Analysis of DUNE Grounding Plan

This note looks back at the DUNE grounding plan and suggests any additional requirements/mitigations. Before proceeding with the ground plan, it is advisable to test and make sure there is no significant amount of moisture which can affect isolation between the “Detector Ground” and the “Cavern Ground and Ufer Ground” references.

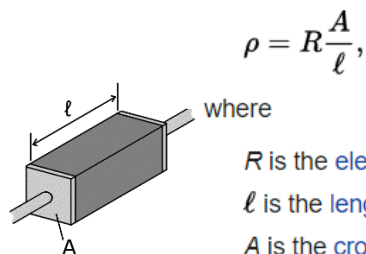
The beam structure on the bottom of the cryostat is 0.4m wide at 1.6m centers along the length of the cryostat. Transversely, there are 6 beams along the full length, 9 beams at the ends (on 1.6m pitch). See picture below.

Here is a tally of the floor contact area:

beam type	area	number	total
long beam	26.4	6	158.4
short beam	2.2	6	13.2
transverse beam	7.6	39	296.4
overlap (double counted)	0.16	246	39.36
total contact surface			428.64

The total surface is about 430m².

From McMaster Carr, ½” FRP plate cost \$230/m², FR4 is about \$400/m². The total material cost is 100-200k\$.
